MASTER DEVELOPMENT PLAN

THE ENCLAVE AT HAUSMAN

MDP# 869

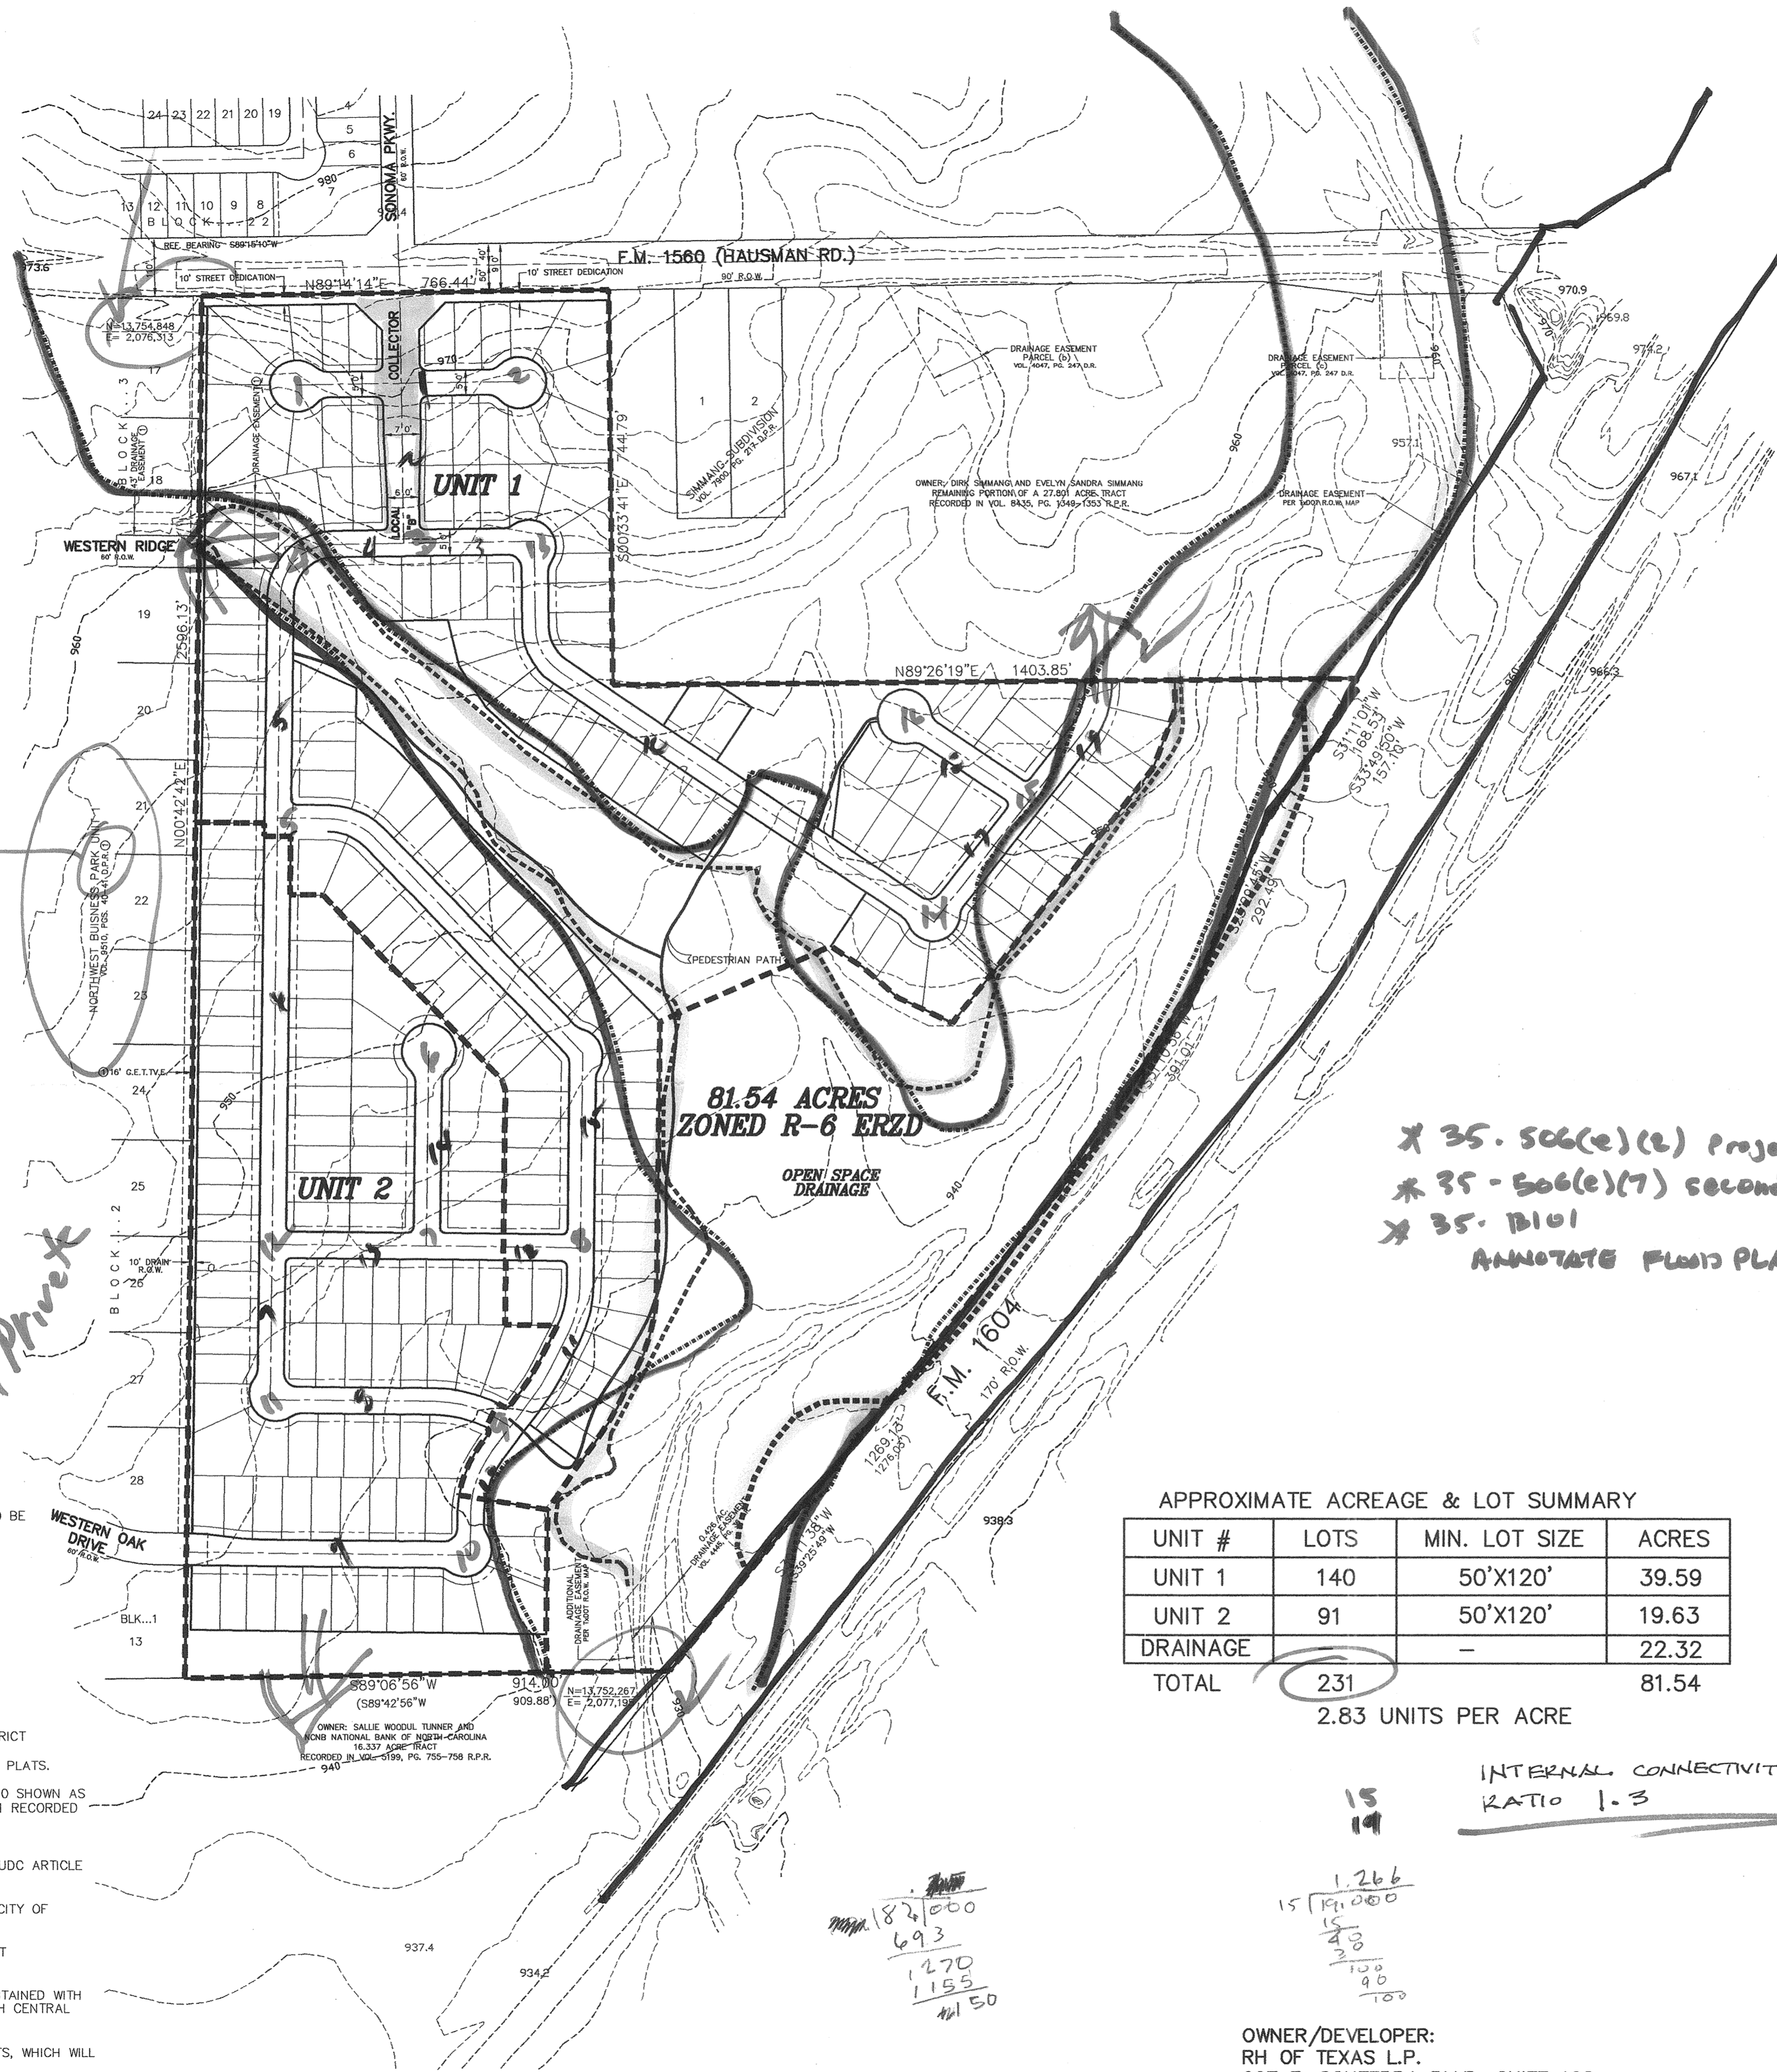
\* 35.506(e)(2) Projection  
\* 35.506(e)(7) secondary  
\* 35.1101  
ANNOTATE FLOOD PLAIN

Connectivity 83 =  
23 / 19 = 1.21

MASTER DEVELOPMENT PLAN

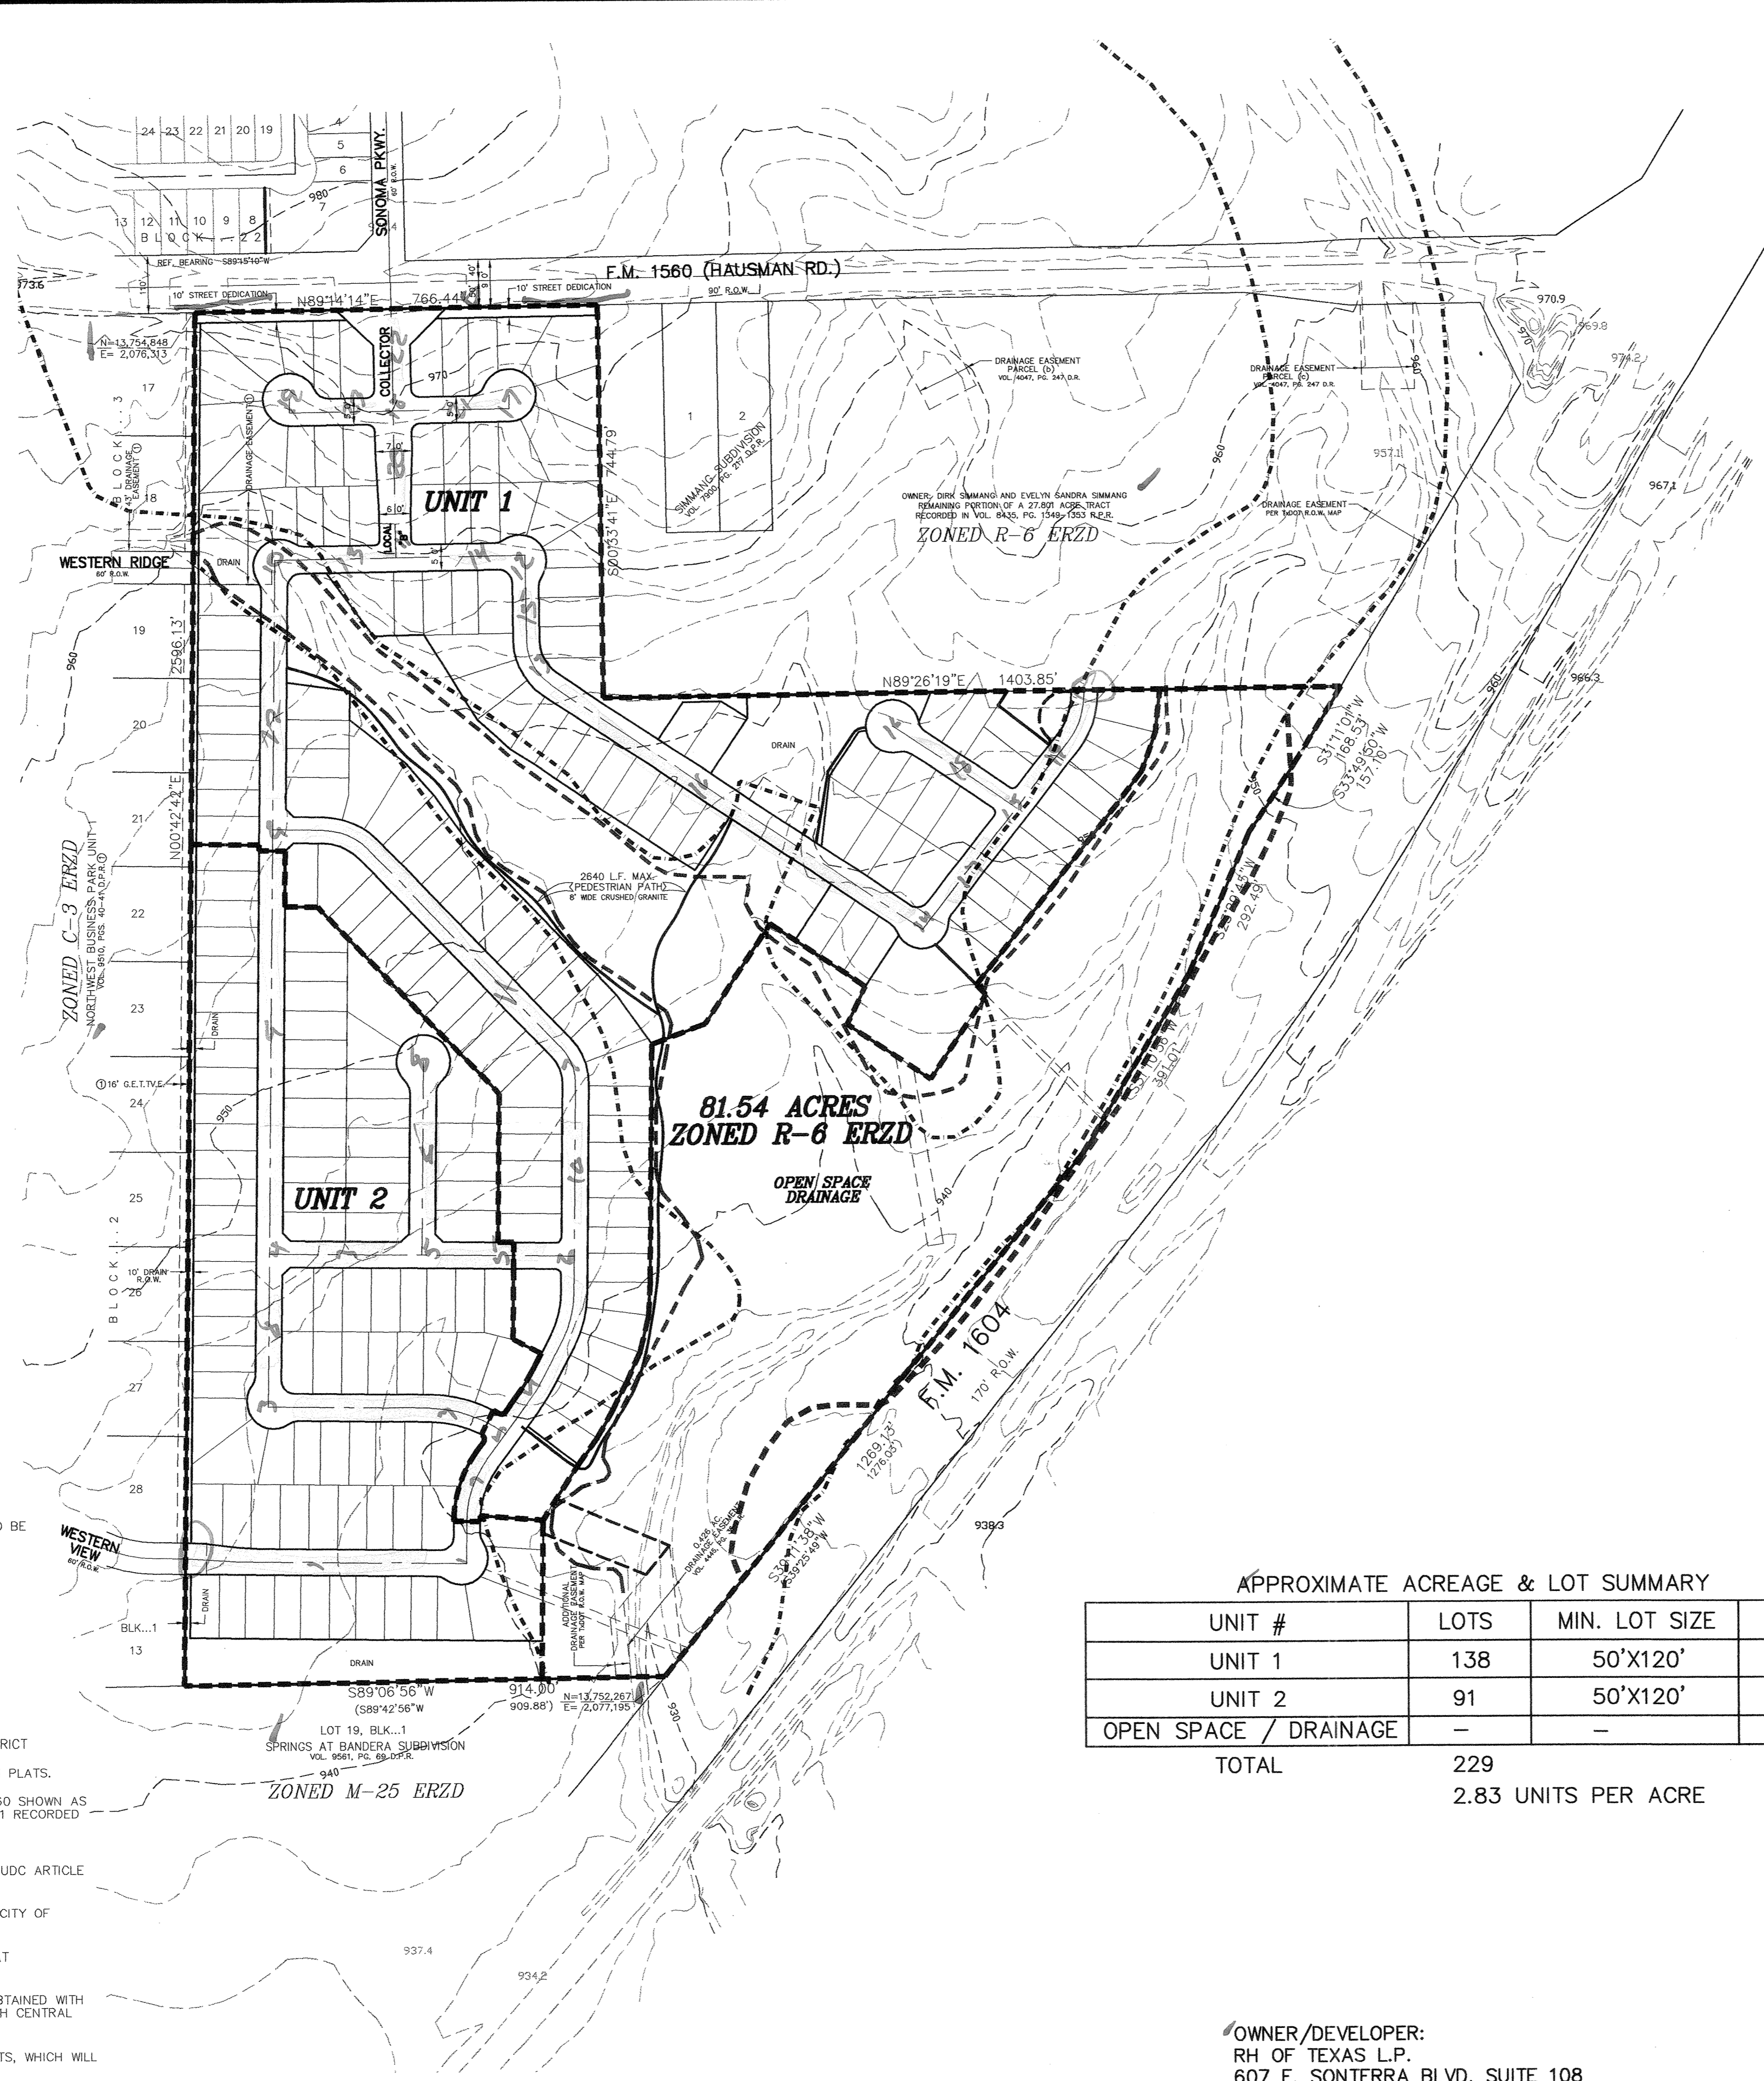
NO.	ITEM DESCRIPTION
1	New MDP
1	Request for review form
	Trish,
	<b>This should answer the question about access to the south of this MDP and</b>
	the zoning of the adjacent properties.
	Please let me know if something else is needed.
	(Our surveyors are meeting with the tree people today)
	Gary Received _____ Date _____

REVISED:  
10/20/2005 UPDATED SOUTH ADJONER  
& ADJOINING ZONING
